HISTORIC AND DESIGN REVIEW COMMISSION

Agenda Item No: 23

HDRC CASE NO: 2016-167
ADDRESS: 1441 SE MILITARY DR
LEGAL DESCRIPTION: NCB 7657 BLK LOT W IRR 447.39 FT OF P
ZONING: C3NA H RIO-5
CITY COUNCIL DIST.: 3
DISTRICT: Mission Historic District
APPLICANT: Jason Feuge/MDN Architects, Inc
OWNER: Security Service Federal Credit Union
TYPE OF WORK: New Construction

RE: HDRC Response to Recommendation
SSFCU
1441 SE Military Dr.
San Antonio, TX
Mdn Project No. 2015075

BIKE RACK DETAIL

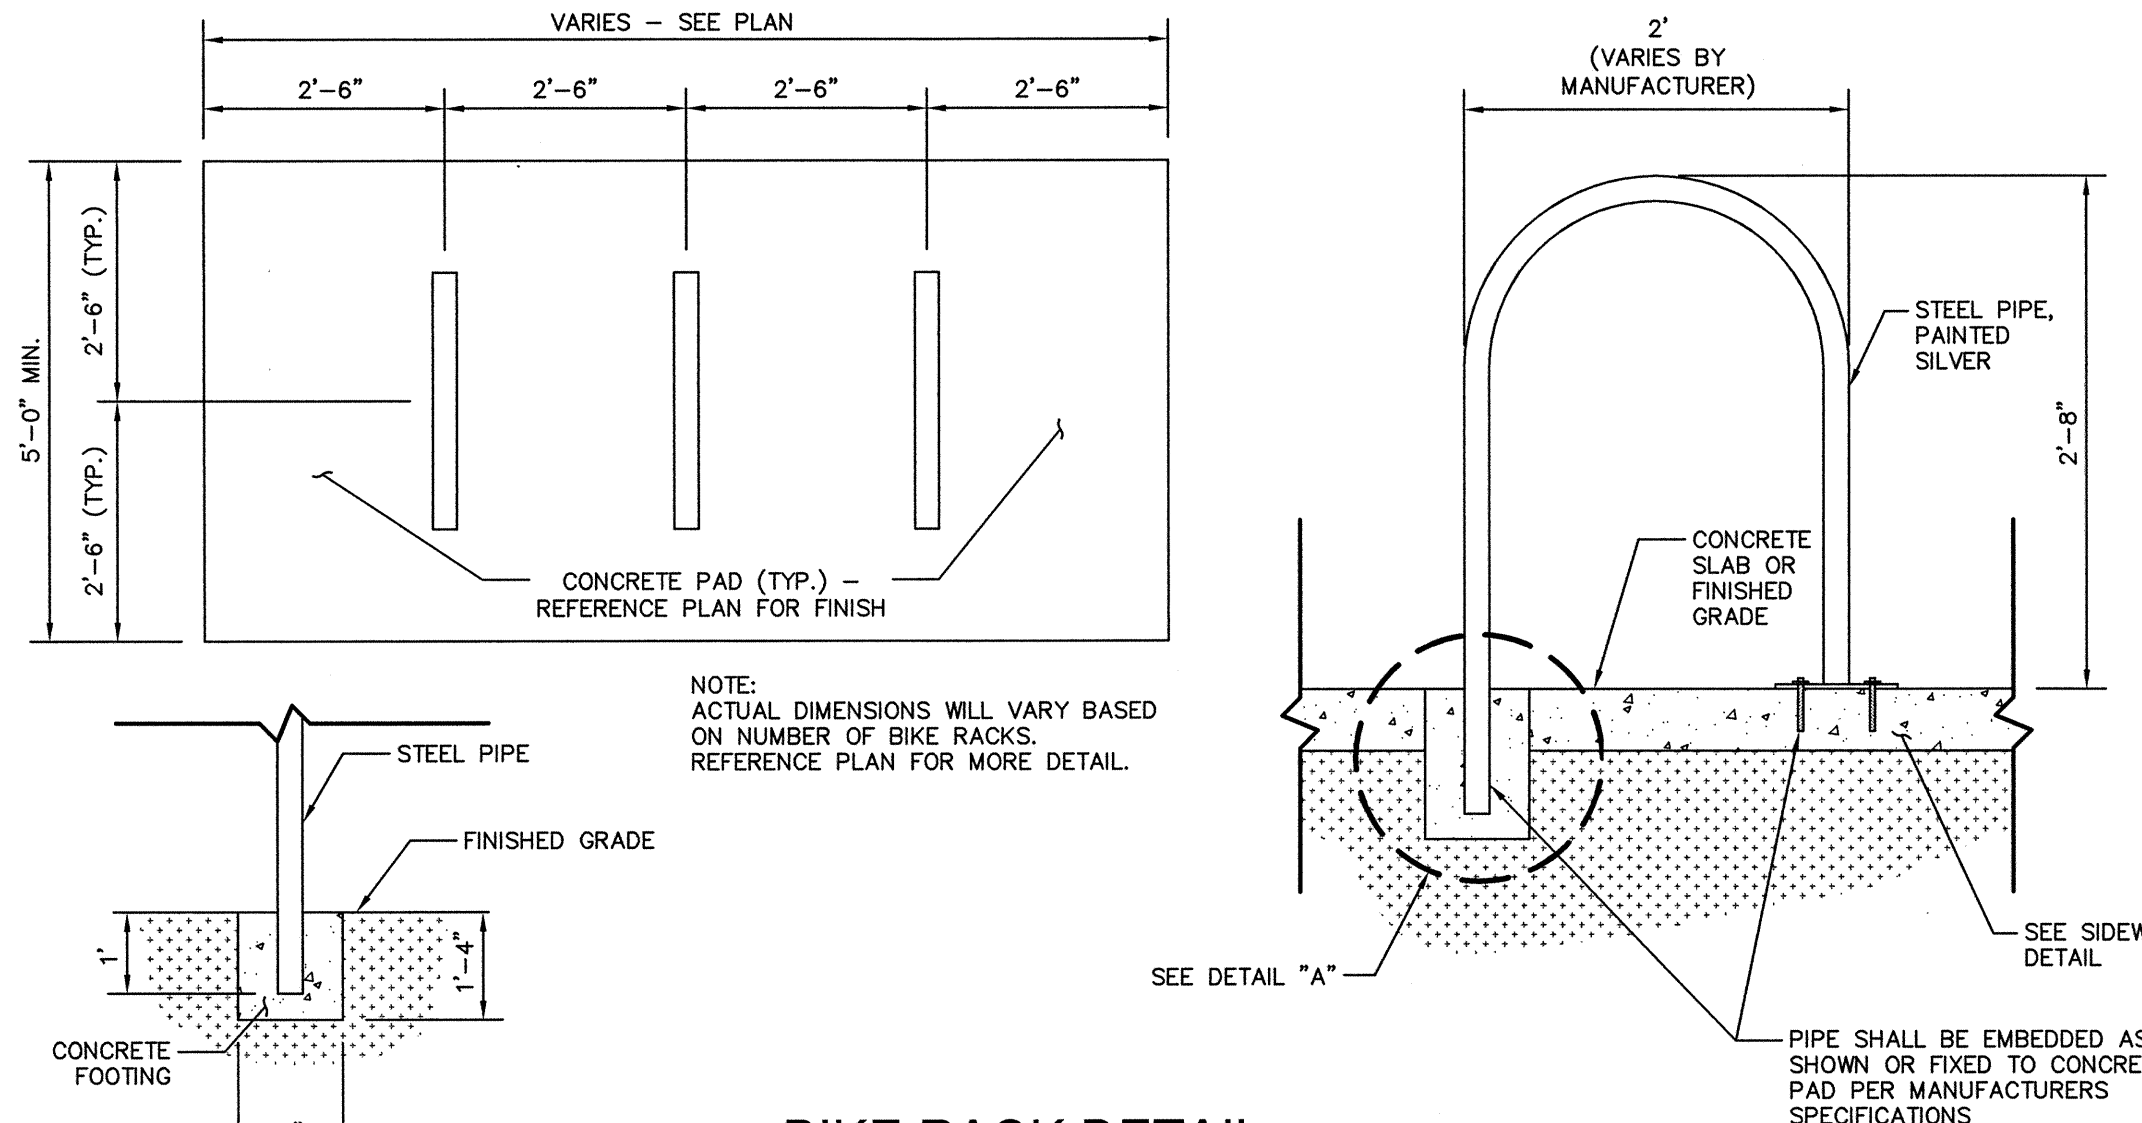
5. That the applicant provide bicycle parking on site as noted in finding k.

Response: *Please see the site plan and site plan detail sheet included that indicates the location and amount of bike racks per the City of San Antonio UDC. (Sheet C1.0 & C7.0)*

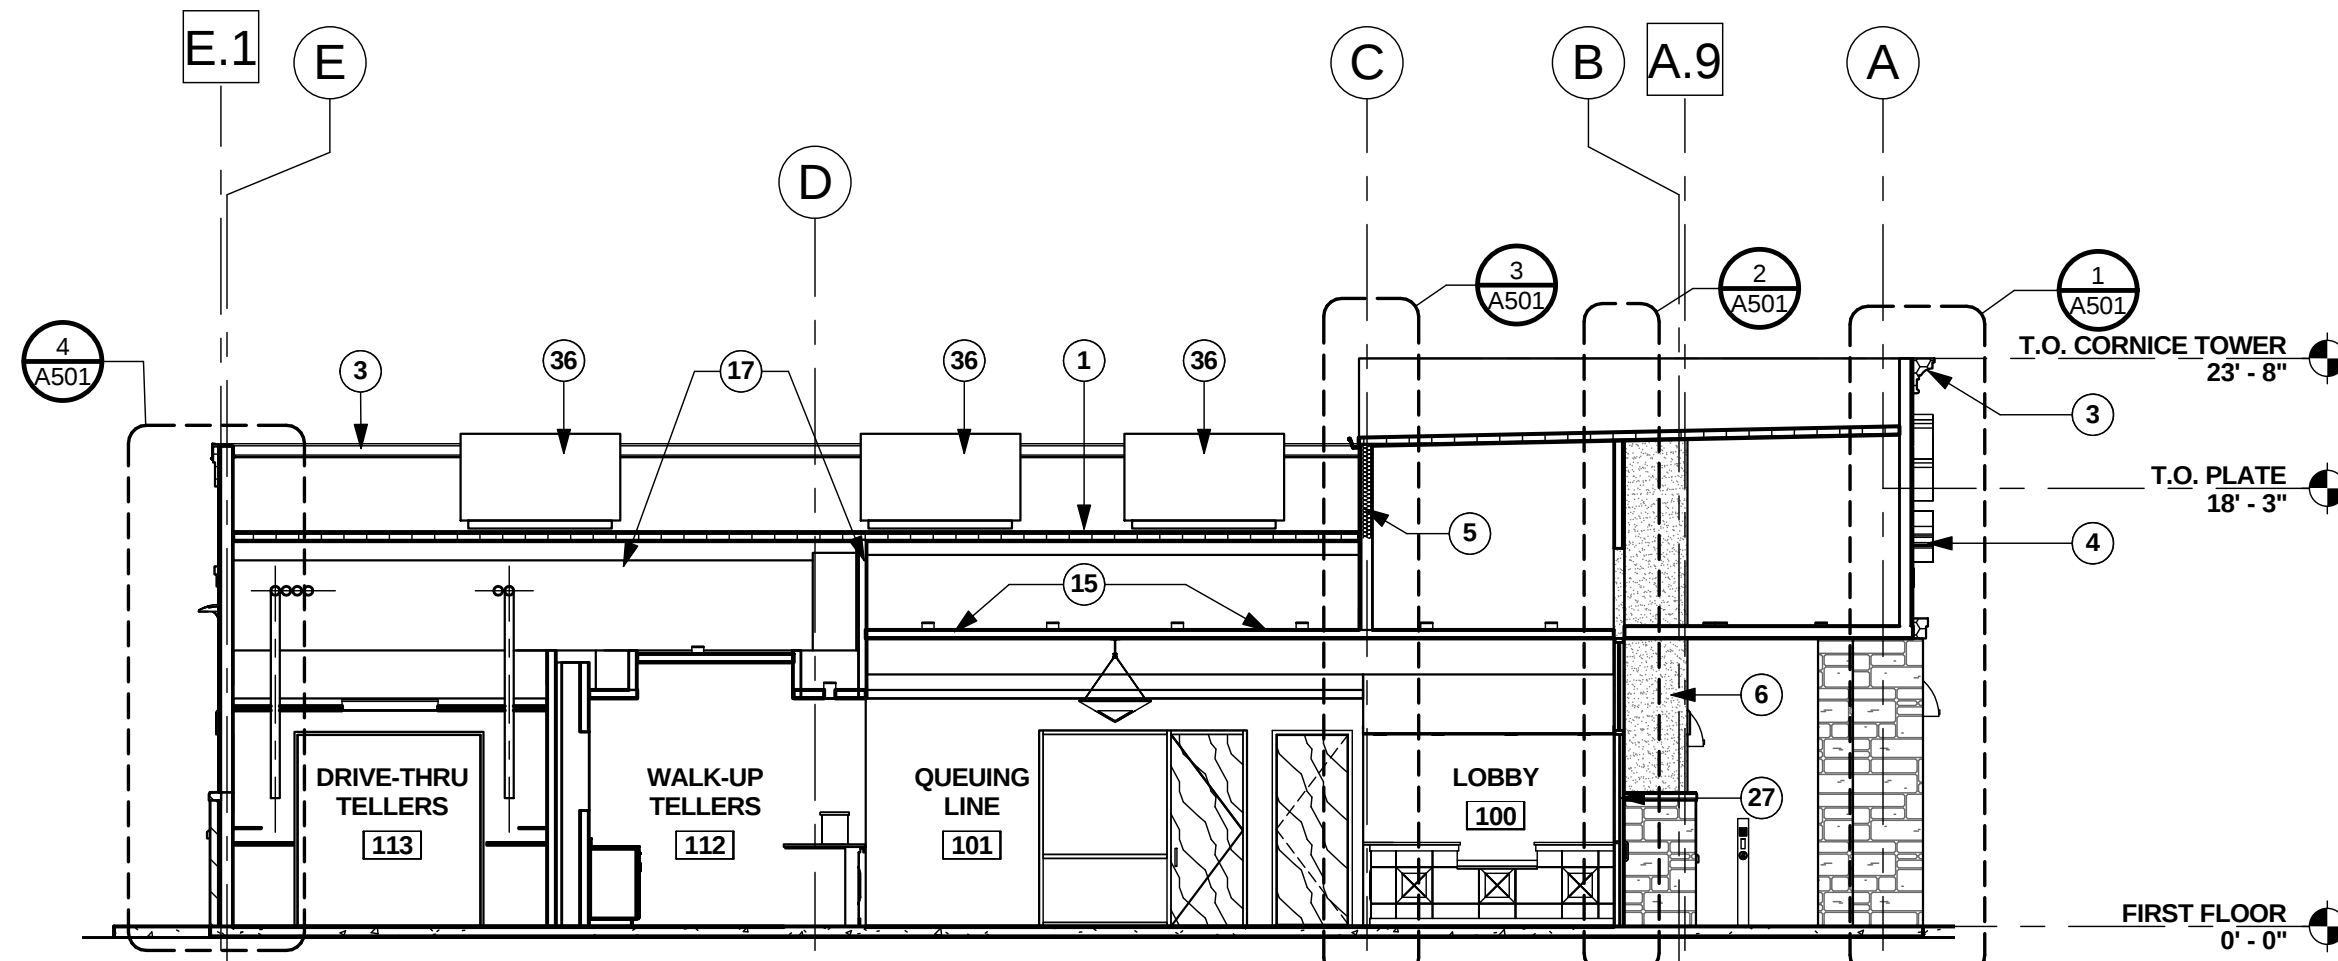
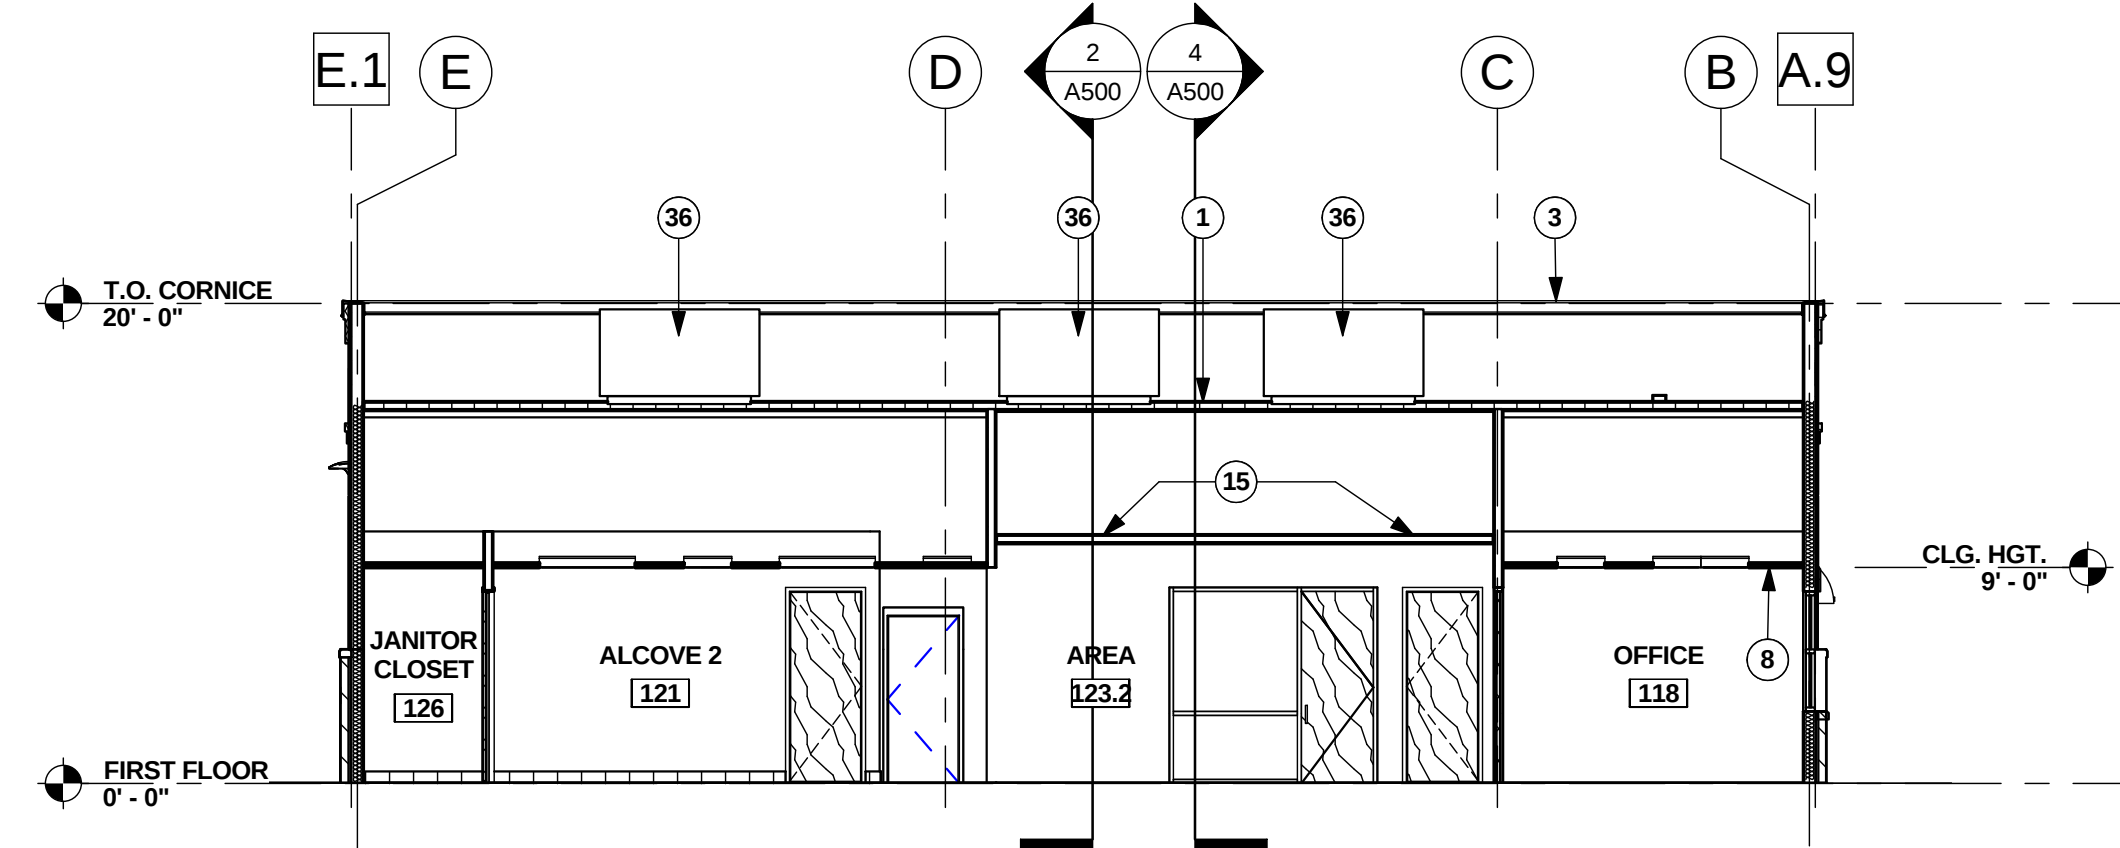
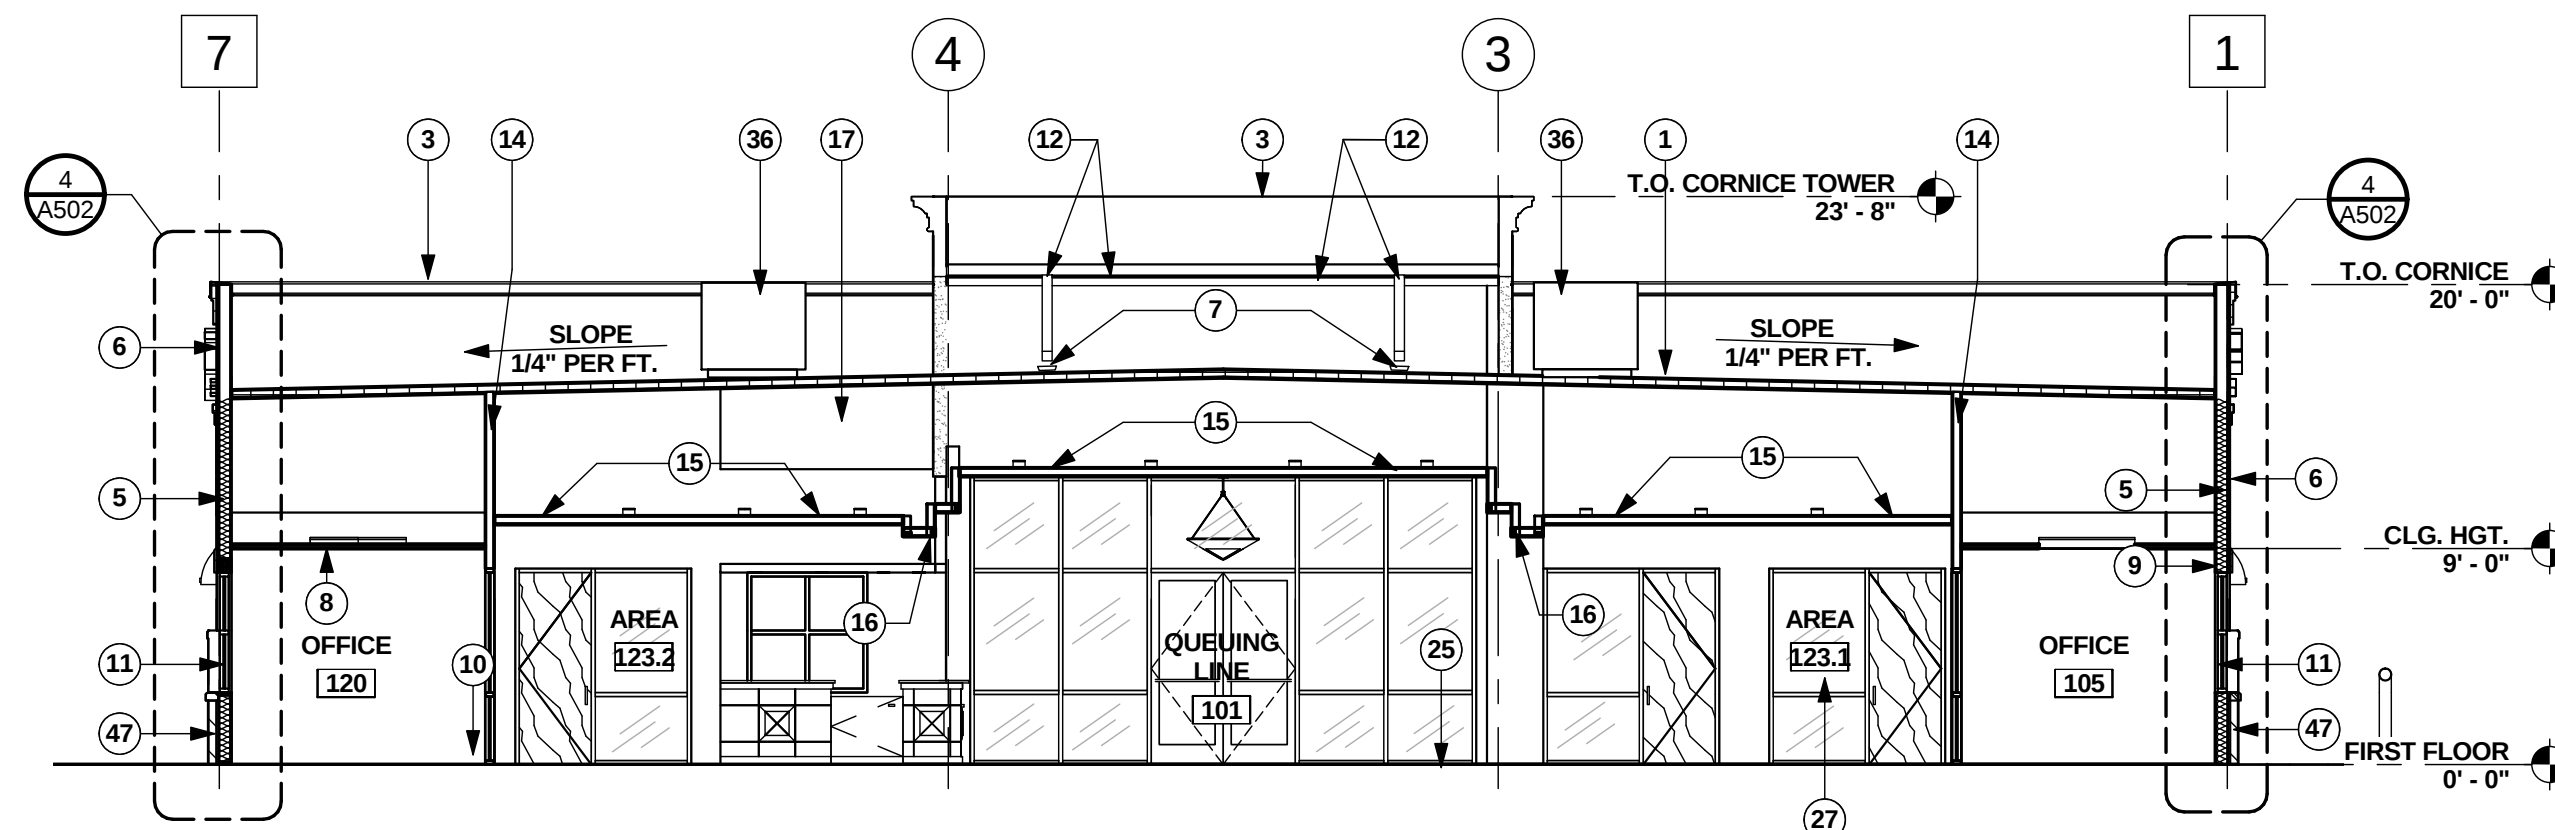
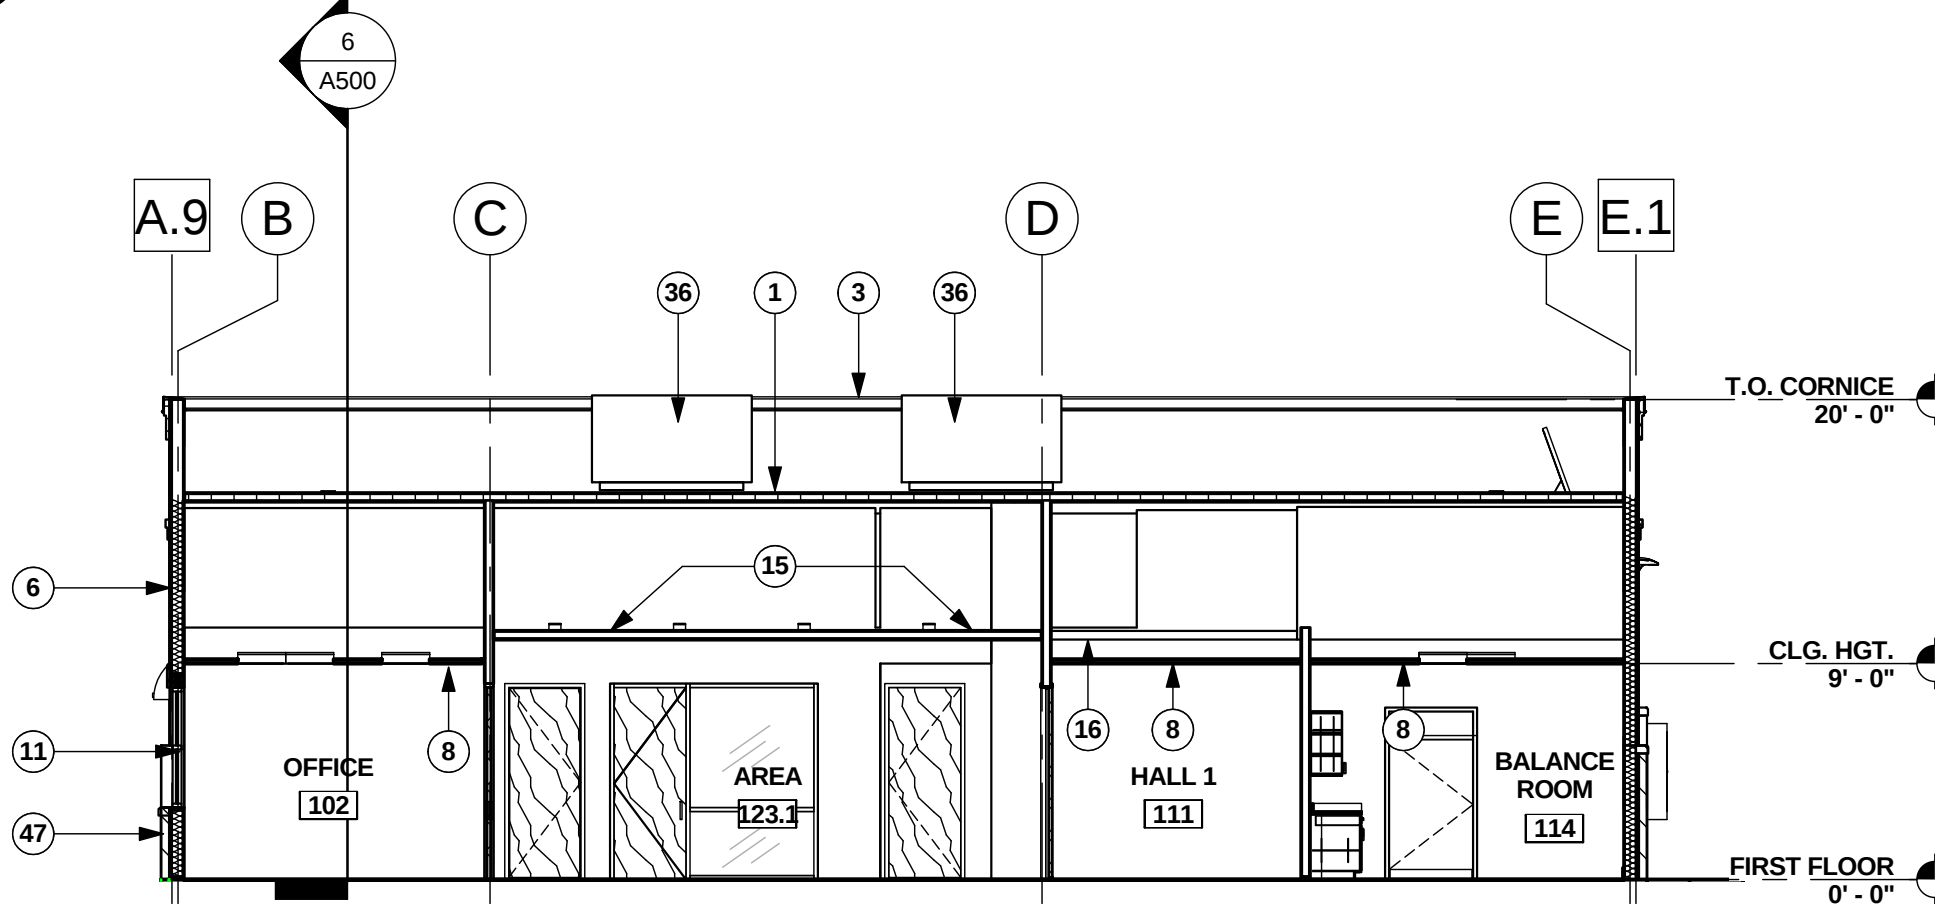
-
4. That the applicant provide information in regards to the location and screening of all mechanical and service equipment as noted in finding j.

Response: *Please see the building sections provided on sheet A500, which shown the roof top units, and the parapet that completely screens the units.*
